TECHNICAL DATA SHEET

FOR PUBLIC HEARING
 PETITION NO. 98-98

Wendover Heights
 Grubb Management, Inc.

SUBJECT: Administrative Approval for Petition No. 98-98 by Grubb Properties, Inc., Tax Parcels 157-081-05 and a portion of 157-072-41.

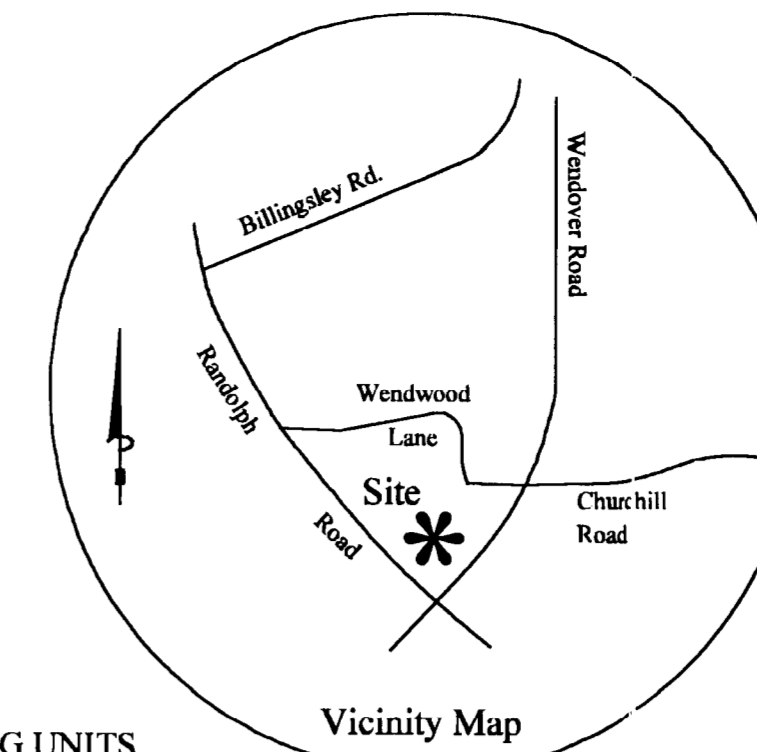
Attached is a revised conditional plan, which clarifies note number 15 regarding right-of-way dedication. Since this request is for clarification purposes only, I am administratively approving this plan. Please use this revised plan when evaluating requests for building permits and certificates of occupancy.

14. Trash collection for the site will be provided with roll out containers by a private contractor.
15. The Petitioner agrees to dedicate those portions of the Site for right-of-way purposes that are required to provide a 50 foot wide right-of-way north of the centerline for Wendover Road, in the areas of development that the City will not acquire, prior to the issuance of any certificate of occupancy of any building constructed on the Site. See Acquisition and Dedication Sheet.
